E
	Application No.	Applicant(s)
Notice of Allowability	10/695,598	LETENDRE, MICHEL
	Examiner	Art Unit
	Ghassem Alie	3724
The MAILING DATE of this communication appearance All claims being allowable, PROSECUTION ON THE MERITS IS herewith (or previously mailed), a Notice of Allowance (PTOL-85) NOTICE OF ALLOWABILITY IS NOT A GRANT OF PATENT RIOF the Office or upon petition by the applicant. See 37 CFR 1.313	(OR REMAINS) CLOSED in this ap or other appropriate communication IGHTS. This application is subject t	plication. If not included not will be mailed in due course. THIS

## **EXAMINER'S AMENDMENT**

DRW Filled on 12/27/05

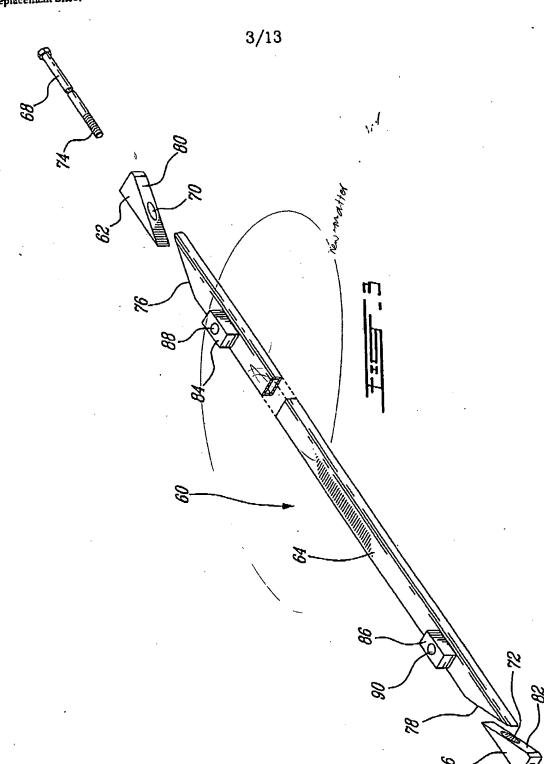
Originally drawings (Figs. 1-13) have been accepted due to the cancellation of claim 6. However, amended Figs. 3 and 4 submitted on 12/27/05 introduce new matter.

Therefore, amended Figs. 3 and 4 submitted on 12/27/05 have not been entered.
